SUBJECT: NuScale Power, LLC Response to NRC Request for Additional Information No. 28 (eRAI No. 8771) on the NuScale Design Certification Application

NuScale Response to NRC Request for Additional Information eRAI No. 8771

NRC Question No.: 15-1

15.0.06 Return to Power

Figure 15.0-10: Return to Power - Net Reactivity (Peak Power Case)

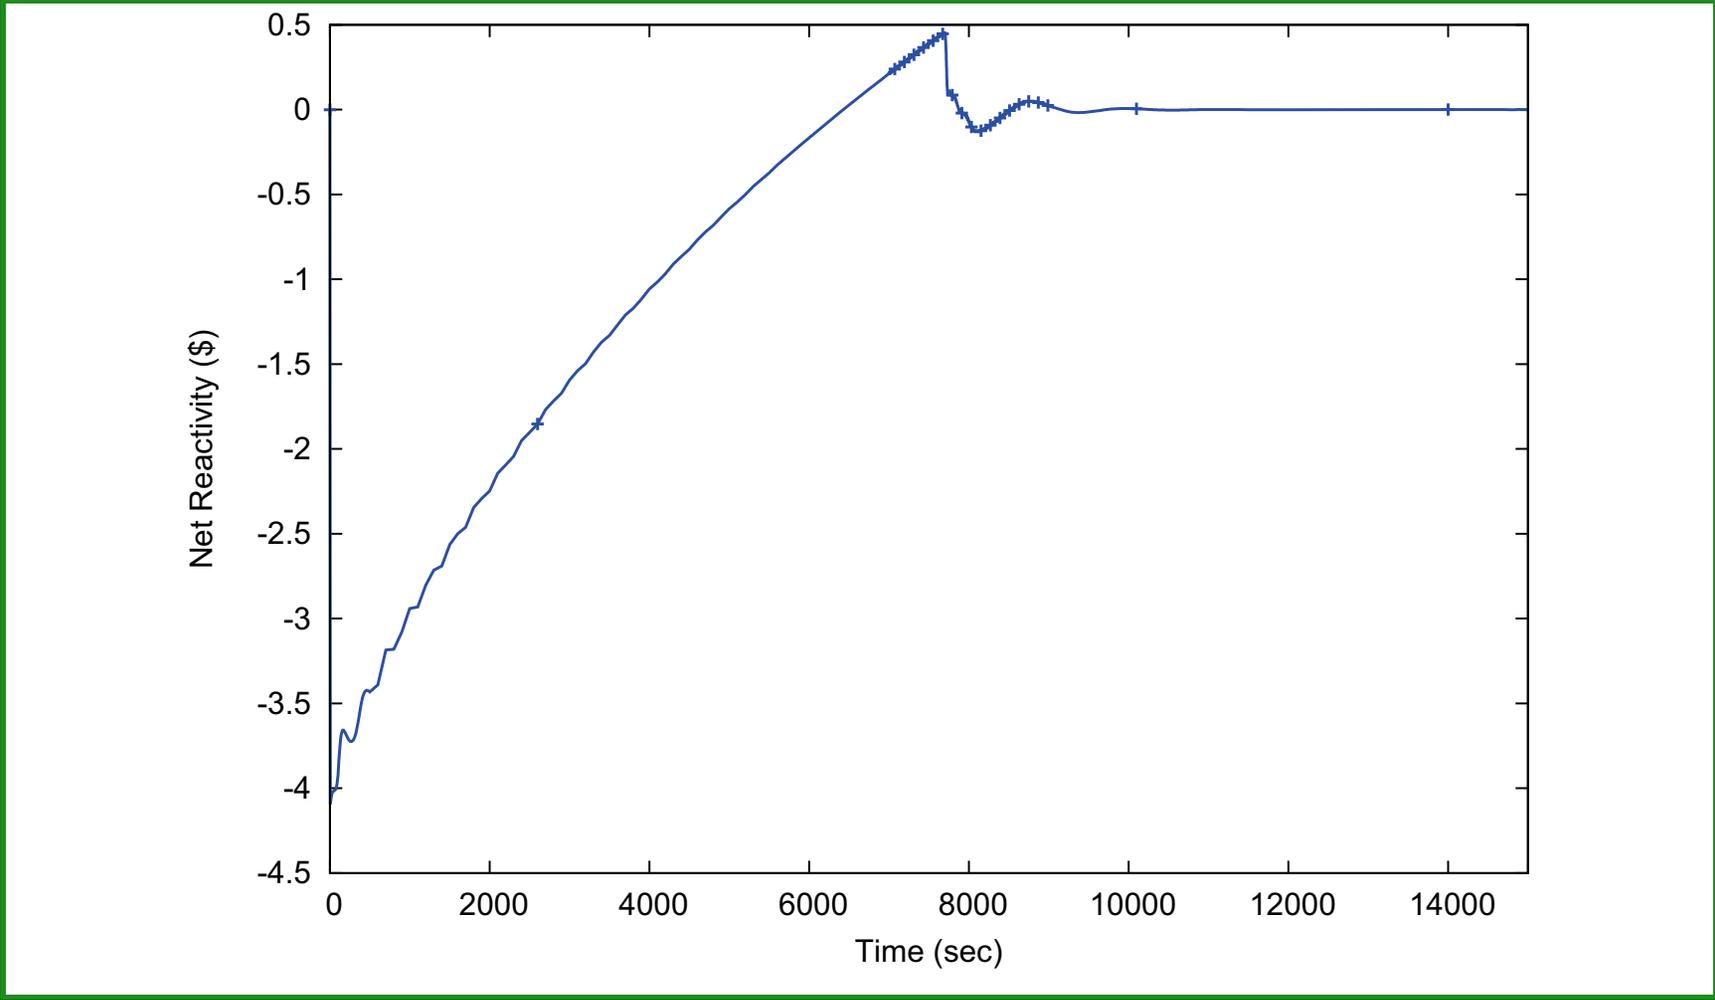
Based on the detail provided in Section 15.0.06, the staff is unable to reach a reasonable assurance finding that the SAFDLs will not be exceeded. The staff is requesting that Final Safety Analysis Report (FSAR) Section 15.0.06, which assumes the use of the decay heat removal system (DHRS), be modified to include details provided for a licensing basis event, and the short term transient analyses in the various subsections of Chapter 15 should reference Section 15.0.06 for the potential long term acceptability of the events. Additional information should include, but not be limited to, a description of the evaluation model(s); the critical heat flux (CHF) correlation used and basis for the correlation (or a reference there to); the assumed radial and axial power distributions and the basis for those power distributions (or a reference there to); and a justification of how reactor stability is maintained under these conditions such that the MCHF can be accurately determined. In addition to Figure 15.0-8, "Power Response on a Return to Power," the staff is requesting the FSAR be updated to include plots of reactor coolant system average temperature, pressurizer pressure, core reactivity, hot channel nuclear enthalpy rise factor (F-delta-H), and MCHF ratio verses time.

The overcooling return to power event begins with an initial negative reactivity insertion that is gradually removed as the transient progresses until a return to power occurs (Figure 15.0-8 and Figure 15.0-10). The biased initial conditions, with increased heat transfer, and low pool temperature results in a slightly larger return to power. A sensitivity analysis on background decay heat shows a minor sensitivity, where higher decay heat results in a slightly slower event progression and marginally decreased peak power. Initial negative reactivity insertion also has little impact on the calculated peak power. Therefore, it is concluded that protection of shutdown margin is insignificant for this event.

The return to power (Figure 15.0-8 and Figure 15.0-10) occurs more than two hours from the start of the transient, meaning the initiating event has little impact on the event progression and results. These cases are initiated from HZP conditions, which subsumes initiation events from hot full power (HFP) conditions due to the nature
